**Subject: Westgate Mall Redevelopment Phase 1 – Site Plan Update Letter**

This letter has been prepared in correspondence to City comments regarding the “Westgate Mall Redevelopment Phase 1 – Site Plan Update Letter” received in July 2020. Each of the City comments are listed below which are then followed by the respective response:

Figure 1: Device locations

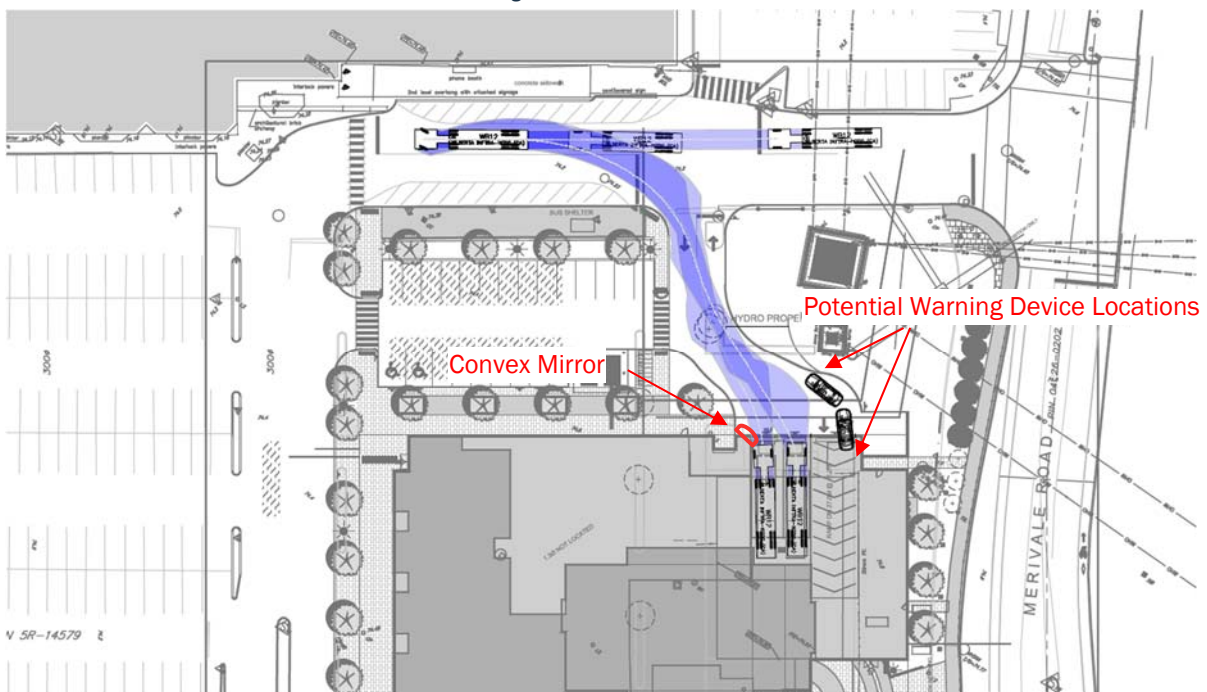
Provide a warning device for vehicles leaving the underground parking to alert them to trucks backing into the truck bays.

A warning device with in view of the parking garage and a large convex mirror mounted at the north west corner of the loading bays are being provided to alert exiting vehicles and to provide increased visibility while reversing into the loading bay. Figure 1, displays the recommended convex mirror location and two potential locations for a warning device to be installed.

Figure 2: Queued Passenger Vehicles at Garage Access

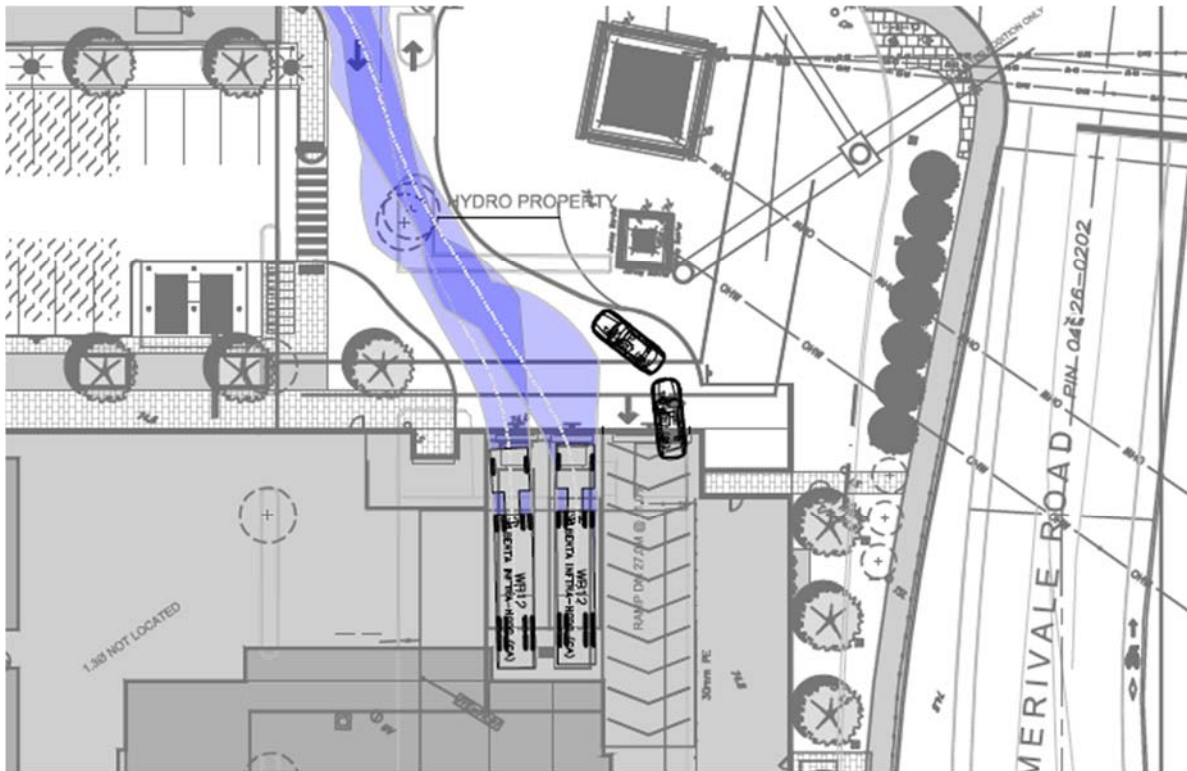
In the event that a vehicle comes out of the underground parking while a truck is backing into the loading bay, provide space for vehicles to wait.

As shown in Figure 2, there is enough space for two departing vehicles to wait on top of the ramp (where one vehicle will be straddling the top of the ramp and the garage door) during periods where trucks reverse into the loading bays. Furthermore, it should be noted that trucks reversing into the loading bays are anticipated to be infrequent, likely occur during off peak periods and will take only a short period of time to complete their maneuvers.

Figure 4: Garage Access While WB-20 is Parked

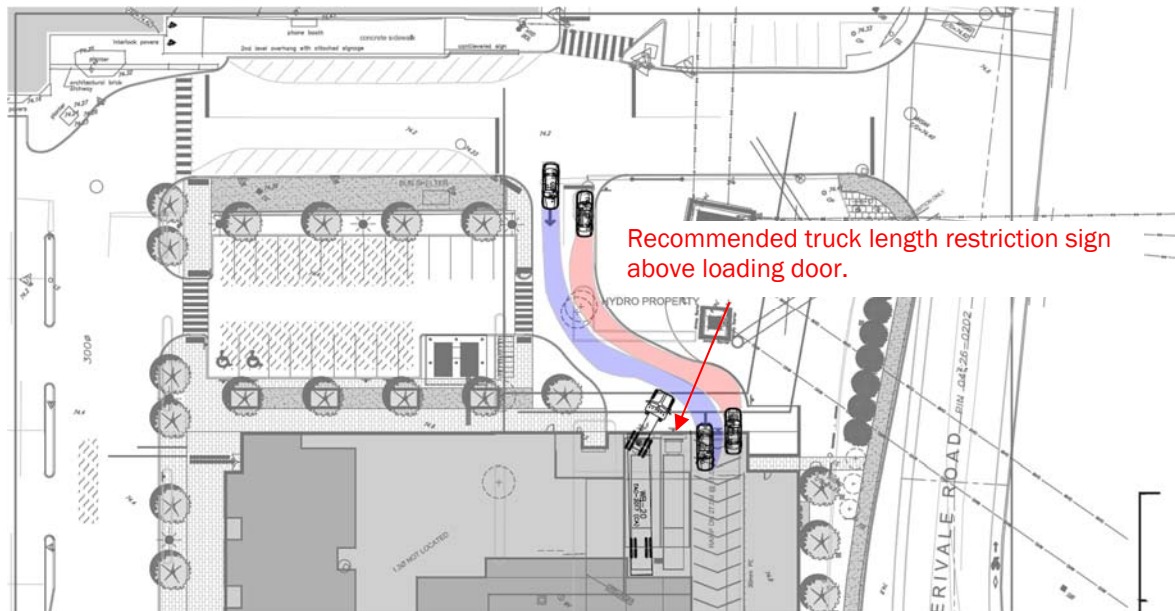
Ensure that trucks parked in the loading bay do not restrict cars from exiting the parking garage.

While a WB20 is parked within the west most loading bay, passenger vehicles retain access to the underground parking even with the reduced drive aisle width as shown in Figure 4. WB-20 sized vehicles with the proposed access configuration will likely have difficulties maneuvering into the east loading bay and since the length of a WB 20 (~22.7m) may confine the drive aisle into the garage, it is recommended that signs be posted above the east loading bay to restrict truck size to shorter vehicles such as the WB 15 (~16.7m) or smaller.
